Panel Reference	2017SSH035
DA Number	DA2017/0451
LGA	Georges River Council
Proposed Development	Demolition of existing and construction of a twelve (12) storey residential flat building comprising of ninety-six (96) residential units and three (3) levels of basement parking, including landscaping and infrastructure works.
Street Address	58-68 Regent Street, Kogarah NSW 2217.
Applicant/Owner	Regent Street Developments PL (applicant) Owners: No. 58 Regent Street: S Wang. No. 60 Regent Street: A Walsh. No. 62 Regent Street: M Hanley. No. 64 Regent Street : J Rohan. No. 66 Regent Street: M and K Khuv. No. 68 Regent Street: Y Xu and Y Yu.
Date of DA lodgement	5 October 2017.
Number of Submissions	To (2) submissions received.
Recommendation	Approval subject to deferred commencement.
Regional Development Criteria (Schedule 7)	Regional development is defined in Schedule 7 of State Environmental Planning Policy (State and Regional Development) 2011. Development with a capital investment value (CIV) over \$30 million. The CIV of this application as outlined in Registered Quantity Surveyors Detailed Cost Report is \$31,131,115.

Executive Summary

Fig. 5 Extract of south (front) elevation demonstrating the extent of the variation to height

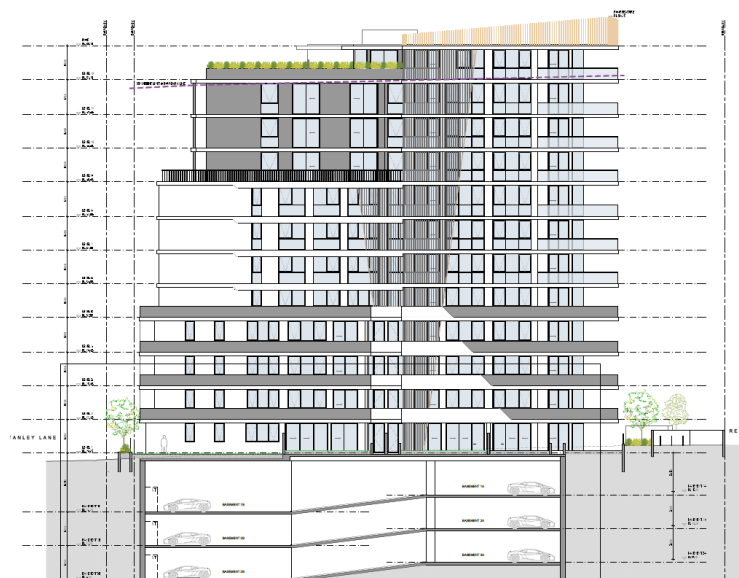
Comment: A Clause 4.6 Exception to Development Standard for a breach in height seeking 38.1 (+5.1m) at the south-west corner which exceeds the prescribed height of 33m contained in the LEP. A Clause 4.3 Height of Building has been lodged for Council's consideration. Clause 4.3 is not a clause excluded under Clause 5.4 Controls relating to miscellaneous uses under the KLEP 2012. The applicant has demonstrated the extent of the variation within the following architectural extracts below;

Comment: The applicant has provided justification for the extent of the variation. As the proposal seeks residential units above the 33m LEP height limit, this results in an undesirable present.

Comment: The applicant's Clause 4.6 Exception for Development Standard relating to Clause 4.3 - Height of Building is not supported as the extent of the variation is not in the public interest as it is inconsistent with the objectives of the particular standard and objectives of the zone.

On 28 May 2018, the applicant provided written correspondence to Council agreeing to the imposition of a deferred commencement condition to delete floor space to comply with the KLEP 2012 height of building limit control of 33m.
